Section 75W Modification Request
Pitt Town Part 3A Concept Plan
(Your ref: MPA07_0140 MOD 4)

Modification Request to the Pitt Town Concept Plan (MPA 07_0140 MOD 4)

Department of Planning & Environment Key Issues MP07 0140 MOD 4

Pitt Town Concept Plan Modification Request (MPA 07_0140 Mod 4)

Drawing Title:
**WASTE, SEDIMENT & EROSION
CONTROL PLAN**
Project No.: L03017.500
Stage: DA
Milestone: 101
Dwg No.: 101
Revision: 4

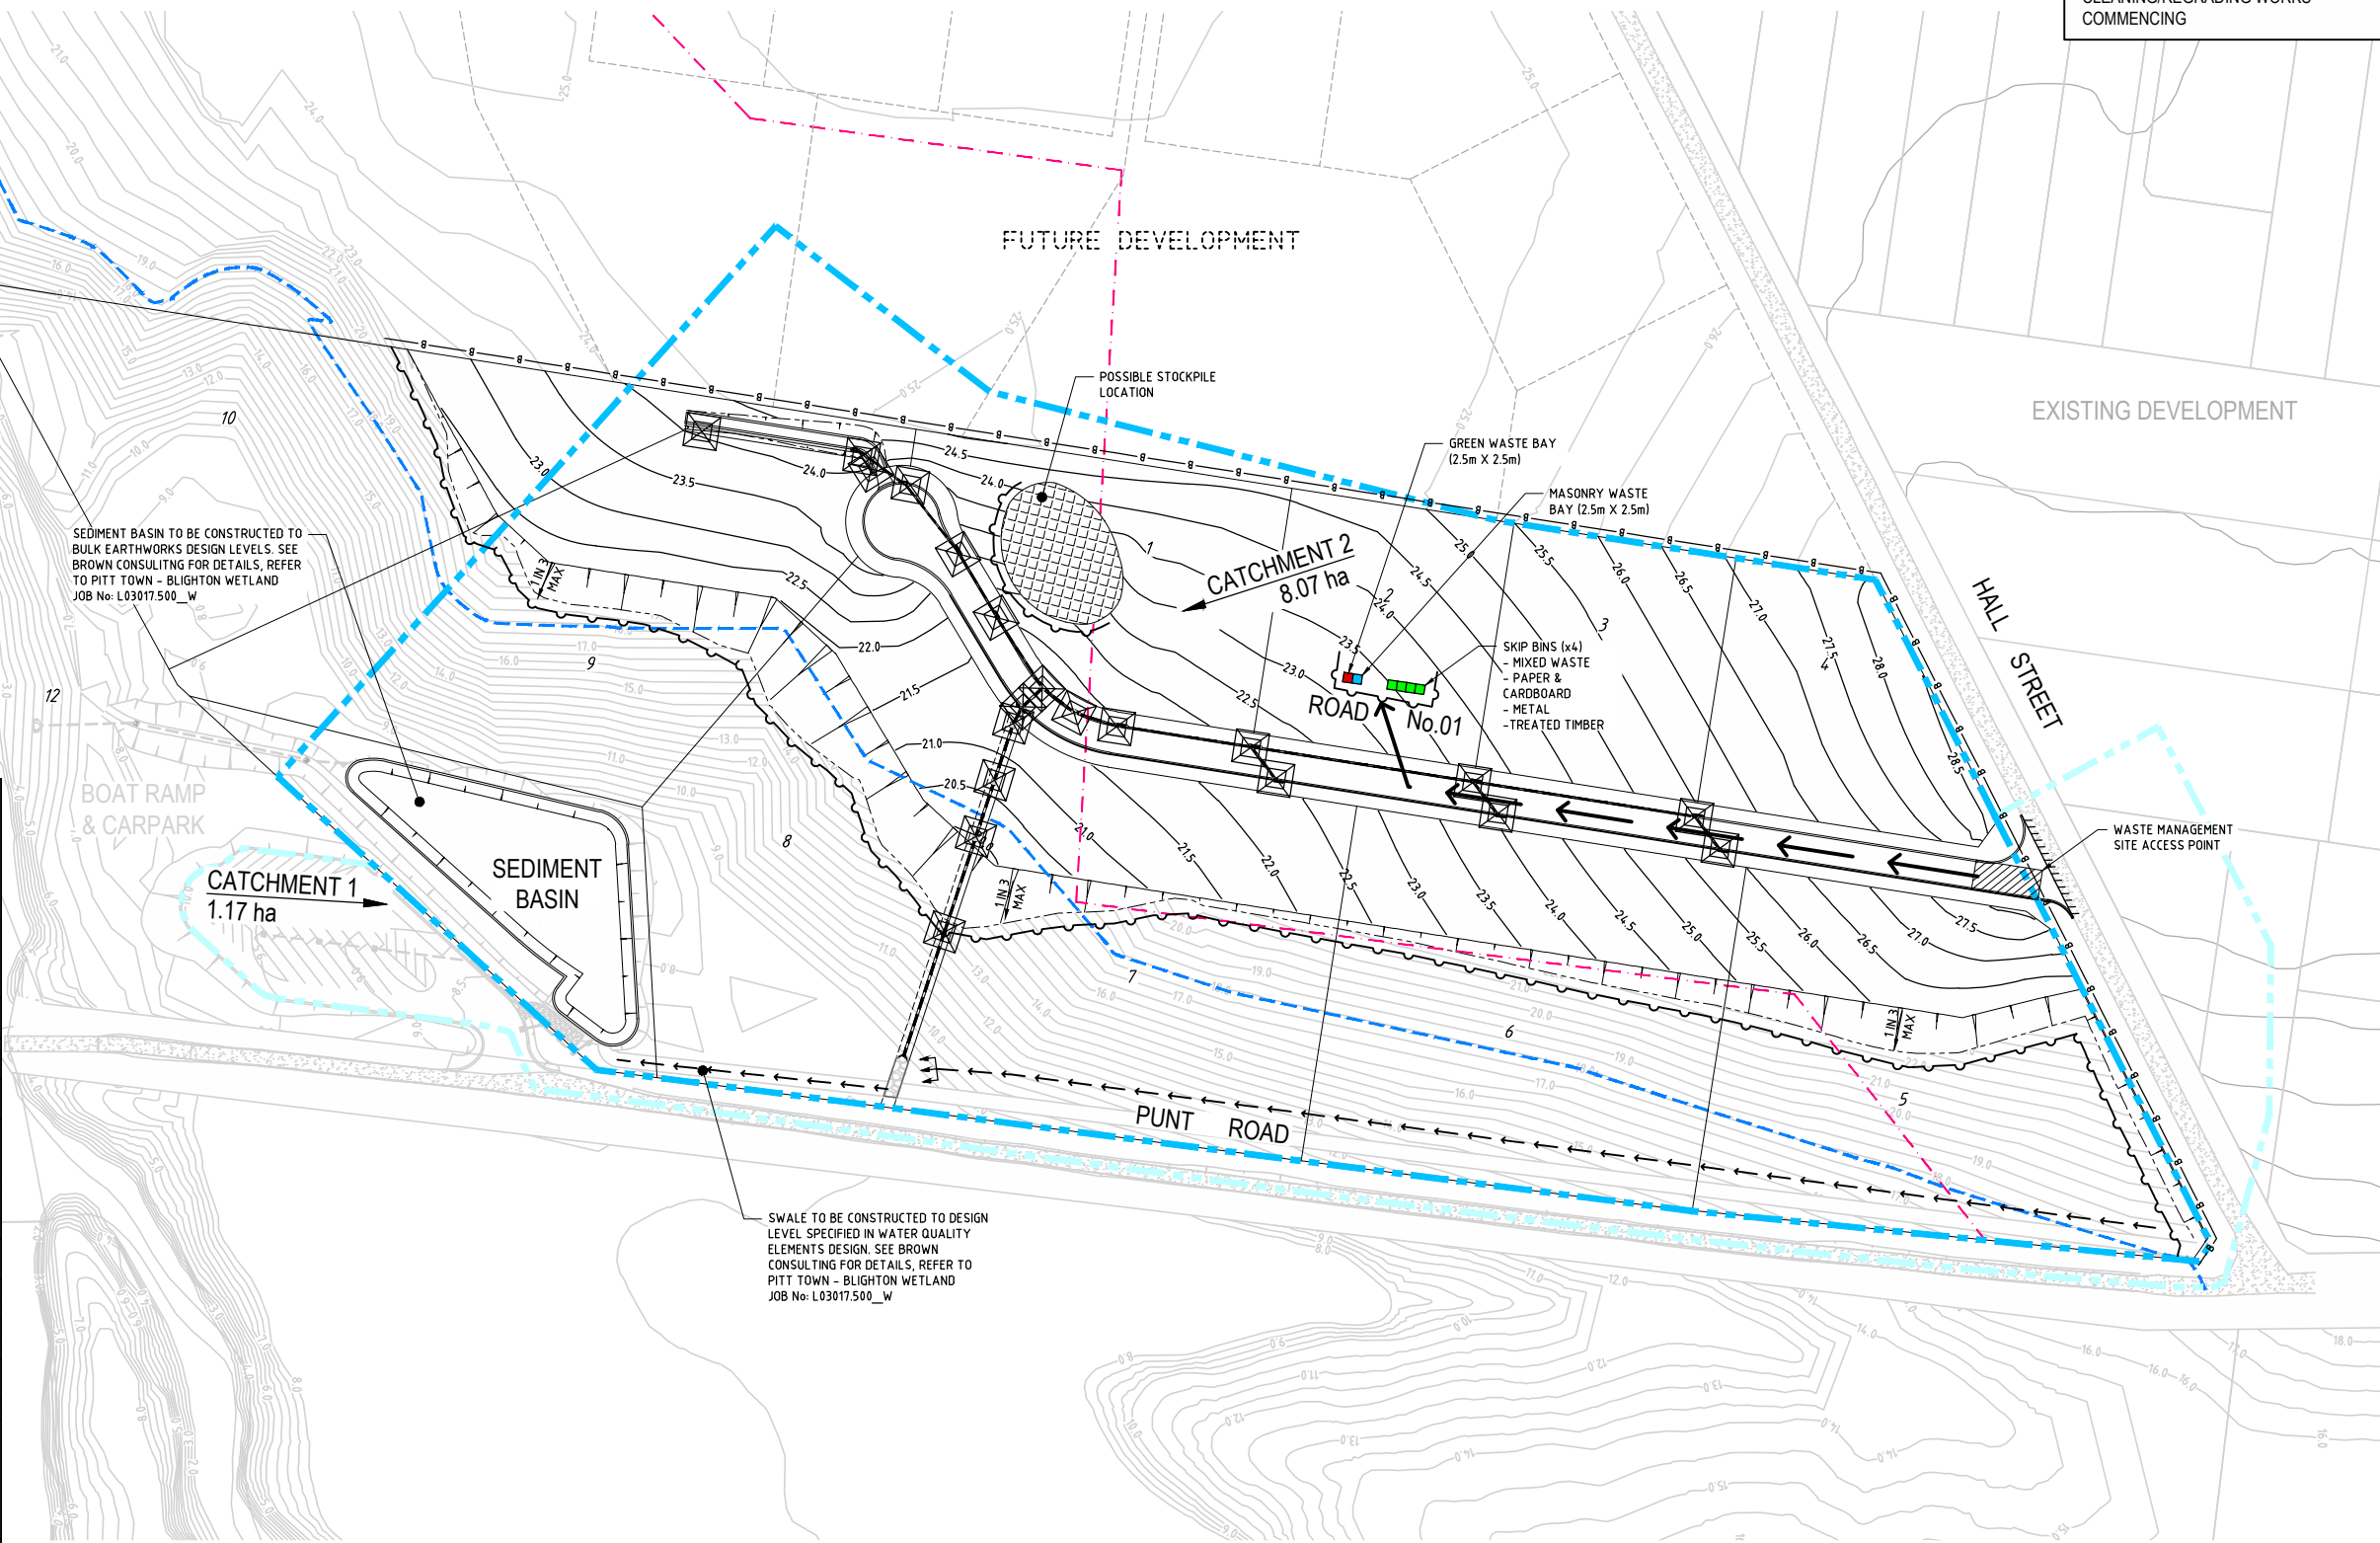
The plans submitted with the amended modification request on 7 August included the provision of an additional residential allotment: Lot 11. The Department has concerns that the additional allotment does not comply with the applicable lot size requirements, could result in adverse heritage and flooding impacts, and increases the density of development on the site without providing an assessment of the associated environmental impacts. On this basis, consideration should be given to deletion of Lot 11 and incorporation of this area within an adjoining allotment. Alternatively, further information should be provided including:

- justification for the lot not having internal road access with access only provided through the flood zone;
- assessment of the impacts of Lot 11 being located entirely within the flood zone and how the commitment to ensure houses are built on flood free land in accordance with the statement of commitments will be achieved;

Proposed Lot 11 is not proposed to be developed for residential purposes. Proposed Lot 11 is to be a future sediment basin/wetland which forms part of the stormwater concept strategy for the future development of the site.

For information, enclosed is a copy of the waste, sediment and erosion control plan that has been prepared for (the existing) Lot 11 and will be submitted with a future subdivision development application. The plan shows the land is to be used as a sediment basin. Ultimately as the subdivision works are completed and dwellings are constructed, the basin will be converted to a constructed wetland and will be a permanent water quality control facility. Full details of the stormwater management concept for the development of the existing Lot 11 will be submitted to Hawkesbury City Council with a future development application for land subdivision.

Proposed Lot 11 will ultimately be land that is to be transferred into the ownership of Hawkesbury City Council. To ensure no housing is allowed on proposed Lot 11, a condition of consent could be imposed to this effect by DPE.

Figure 1: Amended, October 2014 proposal for the Conservation Zones on Lots 11 and 12, showing the proposed subdivision of Lot 11

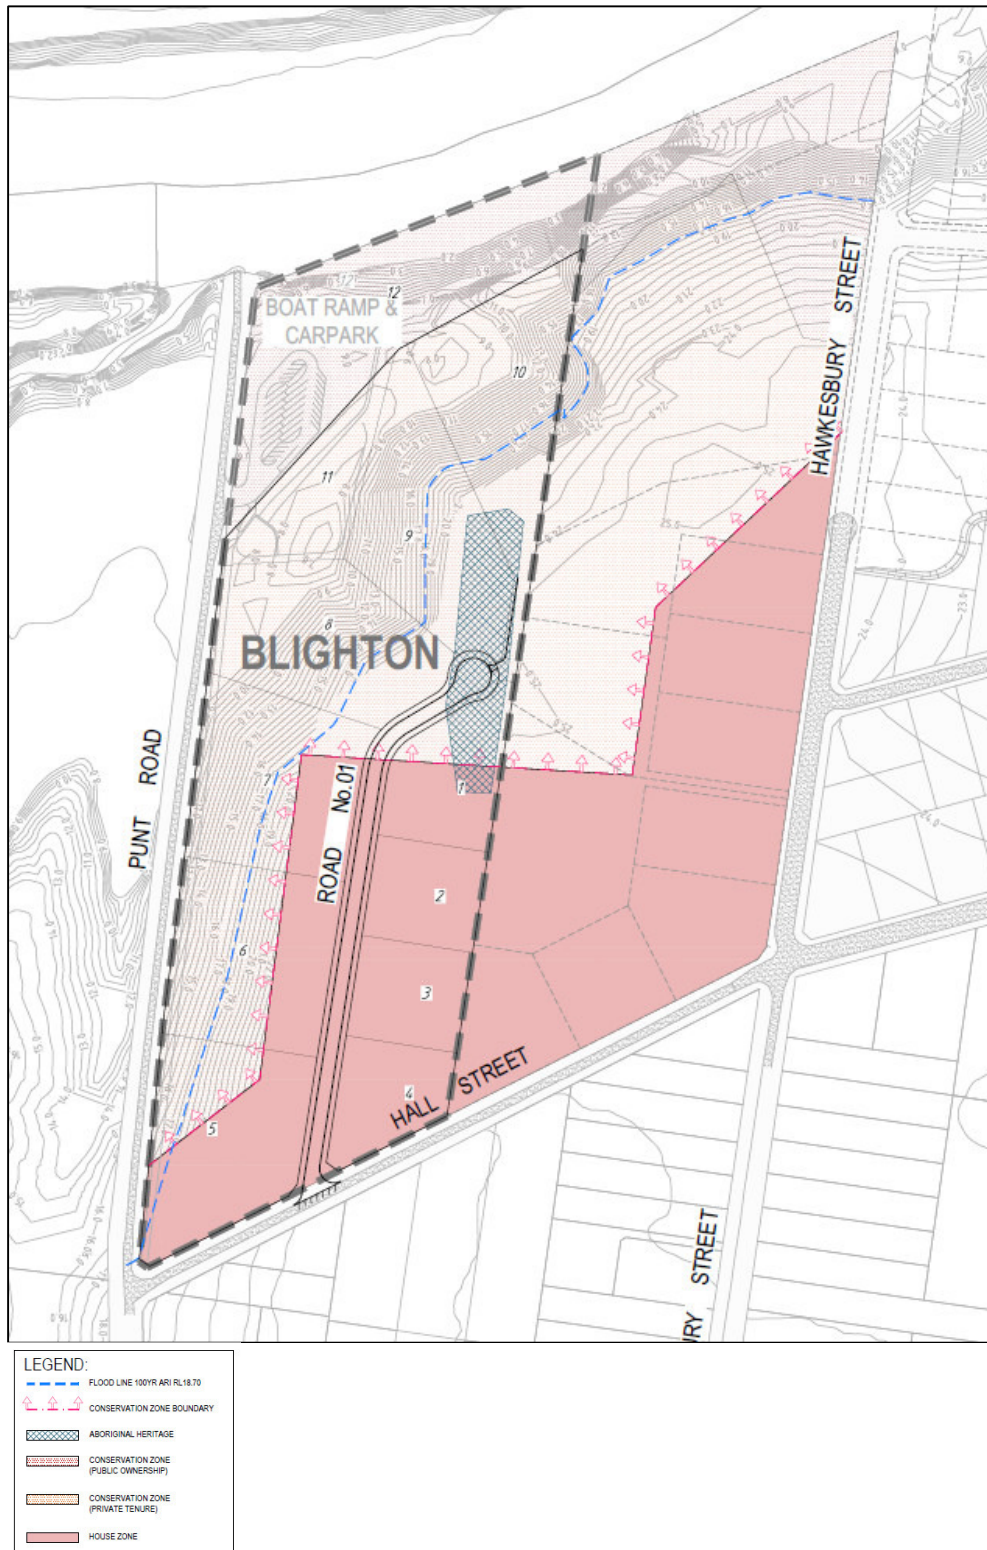
Address any implications of the proposal on the heritage values of the site and the recommendations and conservation policies contained in the *Blighton Conservation Management Strategy* (Graham Brooks and Associates, 16 December 2005), particularly in terms of the Conservation Area which traverses the Blighton Precinct. Your response should address the identified Aboriginal, historical archaeological and historical cultural landscape values of the precinct.

As illustrated on the plan contained in Figure 1, the current proposal within Lot 11 of the so-called Blighton Precinct has been varied from that discussed within the December 2005 *Blighton Conservation Management Strategy for Lots 11, 12 14 and 15, North of Hall Street, Pitt Town, NSW*, and from the amended plan discussed in the December 2007 *Director General's Requirements – Heritage Response*. Specifically, the proposed internal road alignment and lot configuration have been amended to reflect changes in density across the whole of the North Pitt Town area and to respond to the requirements imposed by the current owner of the adjacent Lot 12. In particular, the amended plan involves a new roadway with associated drainage infrastructure.

The amended layout of the subdivision of Lot 11 (Figure 1) has been assessed against the relevant conservation policies formulated in the *2005 Blighton Conservation Management Strategy*, and is provided in the table below. The individual policies have been included in the following table as they apply to subdivision and the European heritage of Lot 11. Some changes to the original text have been made to reflect the limitation to the assessment of the subdivision of Lot 11, excluding Lot 12.

The new layout for subdivided Lots 1 to 7 is consistent with the relevant conservation policies established in the December 2005 *Blighdon Conservation Management Strategy for Lots 11, 12 14 and 15, North of Hall Street, Pitt Town, NSW*, as they are either entirely or partly located on land denoted as “House Zone”.

Subdivided Lots 5 to 7 extend into the Conservation Zone, however, dwellings can and should be located in the portion of the lots identified for housing (“House Zone”).

The new subdivided Lots 8 to 11 are located outside the land denoted as “House Zone” and are contained entirely within the land previously identified for a Conservation Zone. Future applications for development on these lots will need to consider and protect any Aboriginal and/or European archaeological relics present. Dwellings and associated houses can and should be located on the ridge, to ensure limited close up visibility from Punt Road or the river, due to the sloping topography below the ridgeline.

The repositioned roadway and associated drainage infrastructure will also require consideration of those impacts and any relevant heritage consents at DA stage, given that it extends into the previously identified Conservation Zone.

The new subdivided Lot 11 is unlikely to be used for private housing as access to this lot from Punt Road is below flood level.

The amended subdivision and road layout for Lot 11 should be approved on the basis that there is an acceptable level of heritage impact.
